TOWN OF PLAINFIELD DESIGN REVIEW COMMITTEE REPORT

CASE NO.: [DP-25-090](#): Plainfield Innovation Park IV

REQUESTED ACTIONS: Architecture and Site Design for a 227,760 (+/-) square foot building on a 13.96 acre (+/-) parcel to be created in a concurrent primary plat within an area zoned I-2: Office/Warehouse Distribution.

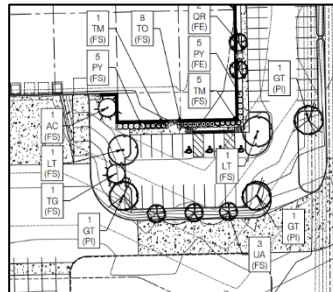
Landscape Plan.

Staff had made a request to the applicants to present the landscape information in a specific way, but it appears that between the intervening holiday shortening the work time between the Project Review Meeting and the resubmittal date as well as lack of clarity within the request, the result wasn't quite what had been sought.

Below is an example of what the Development Guide requests for the landscaping plan. This will allow Staff to review the plan for compliance.

Staff believes that the presentation issues can be resolved prior to the resubmittal for the Plan Commission and asks the DRC to review based upon plant content.
